SUBJECT: ISSUANCE OF AMENDMENT NO. 157 TO FACILITY OPERATING LICENSE DPR-57 -
EDWIN I. HATCH NUCLEAR PLANT, UNIT 1 (TAC 68688)

GEORGIA POWER COMPANY
OGLETHORPE POWER CORPORATION
MUNICIPAL ELECTRIC AUTHORITY OF GEORGIA
CITY OF DALTON, GEORGIA
DOCKET NO. 50-321
EDWIN I. HATCH NUCLEAR PLANT, UNIT NO. 1
AMENDMENT TO FACILITY OPERATING LICENSE

Amendment No. 157
License No. DPR-57

ATTACHMENT TO LICENSE AMENDMENT NO. 157

FIGURE 3.11-1 (SHEET 4)

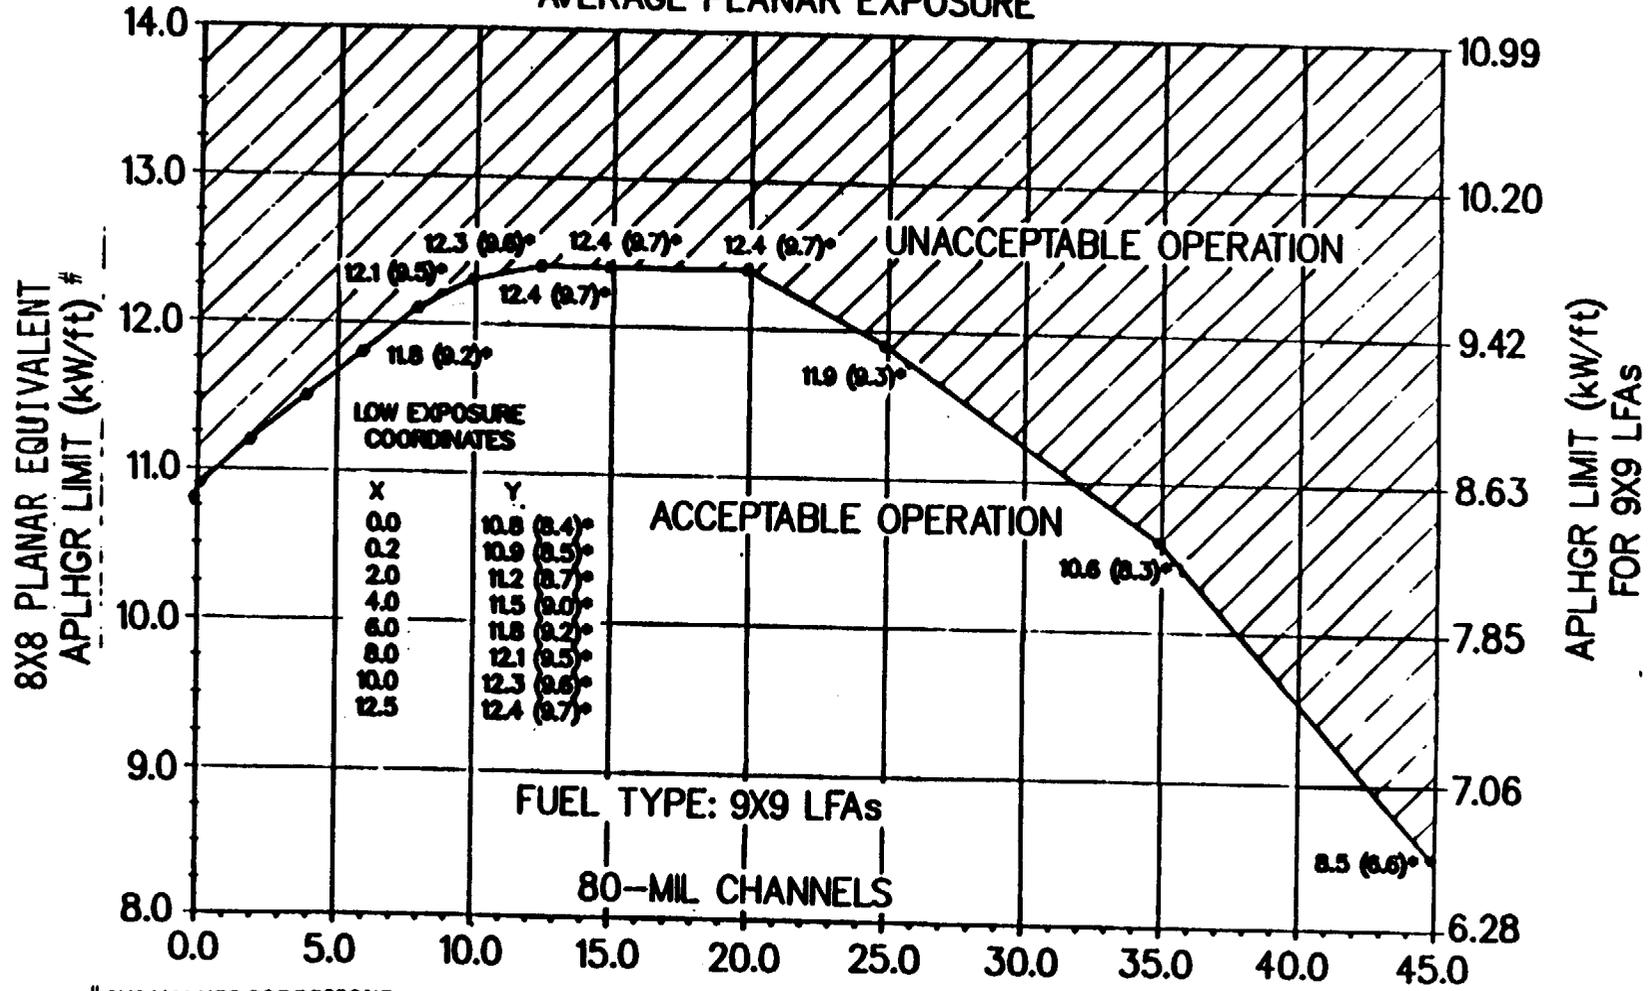
For convenience, the APLHGR limits are reported in the units of kW/ft, which is the bundle planar power normalized to the number of fueled rods. Figure 3.11-1 (Sheet 4) shows that the 9x9 LFAs have the same planar power limits as the GE B/P80RB284H fuel; however, on a kW/ft basis, the APLHGR limits for the LFAs are 62/79 times the B/P80RB284H limits.

The ANF 9x9 LFAs have been evaluated by ANF for use in the Hatch reactors. The analysis of these fuel elements is presented in an ANF report, "Hatch 9x9 Lead Fuel Assemblies, Safety Analysis Report," ANF-87-95, Revision 3, 29 March 1988, which was submitted as an enclosure to the licensee's June 20, 1988 request for license amendment. These fuel assemblies are designed to be neutronically similar to the GE B/P8DRB284H fuel such that the existing APLHGR limit (when adjusted to account for the different number of rods) and MCPR thermal limits for B/P8DRB284H fuel are applicable also to the 9x9 LFAs. Analyses of anticipated operational occurrences and postulated accidents presented in the ANF Report, ANF-87-95, show the LFAs will provide equivalent or improved performance as compared with the GE P8DRB284H fuel. The staff has previously evaluated the ANF 9x9 fuel, and approved its use in Hatch Unit 2 by Amendment No. 89 to the Unit 2 TS. On this basis, we find the ANF 9x9 LFAs acceptable for use also in Hatch Unit 1. A new TS Figure 3.11-1 (Sheet 4) is added to depict the APLHGR limits for 9x9 LFAs and is acceptable.

FIGURE 3.11-1 (SHEET 5)

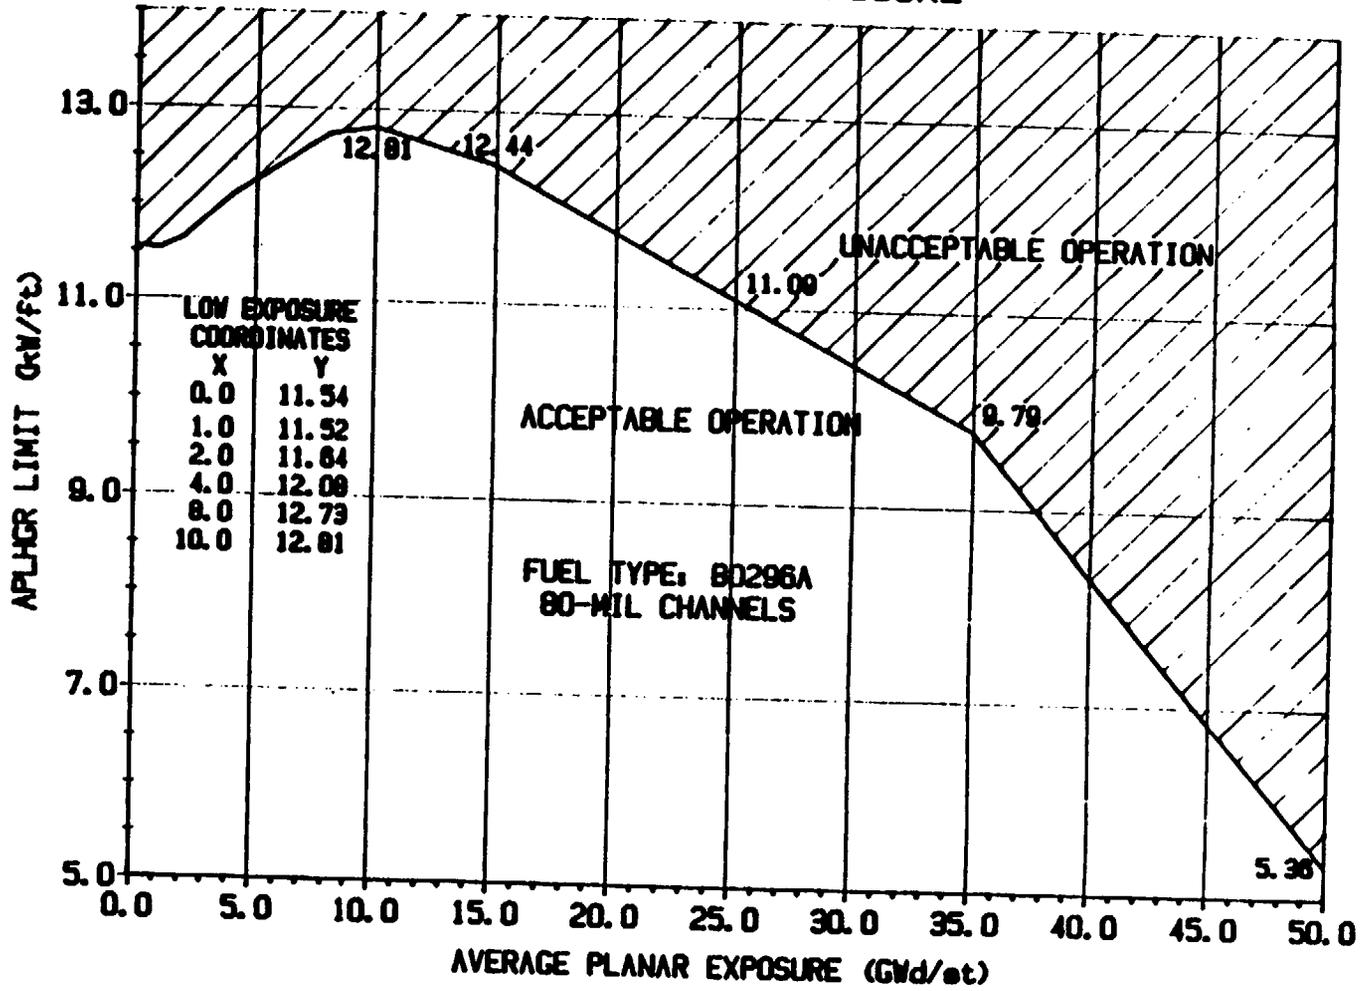
The actual APLHGR limits for GE8x8EB fuel are lattice-type dependent and are explicitly modeled in the process computer. At each exposure, the Technical Specifications APLHGR limit is defined as the most limiting value of all the enriched lattices. The Technical Specifications APLHGR limits will be used for manual calculations.

A new TS Figure 3.11-1 (Sheet 5) is added to depict the APLHGR limits for the BD296A fuel. This change is acceptable.

FIGURE 3.11-4
MCPR LIMIT ALL 8X8 AND 9X9 FUEL TYPES
FOR RATED POWER AND RATED FLOW

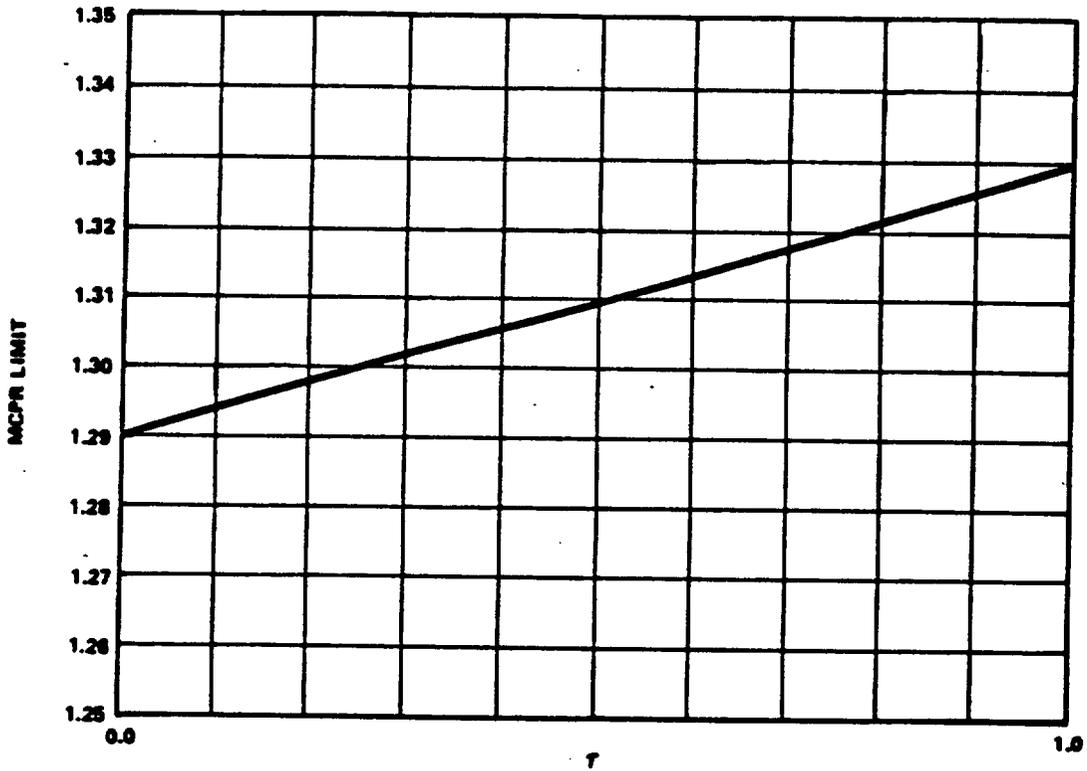
TS Figure 3.11-4 would be modified to indicate that the MCPR limit applies to all 8x8 fuel types and to all 9x9 fuel types. The MCPR safety limits are valid for the GE8x8EB fuel types according to GESTAR-II. The existing MCPR operating limits are expected to conservatively bound the results of the Unit 1 reload transient analyses. The licensee has committed to verify that the MCPR limits do, in fact, conservatively bound the analysis results for each cycle. On this basis, we find that the modified TS Figure 3.11-4 will present MCPR limits for all fuel in use at the plant, and the change is, therefore, acceptable.
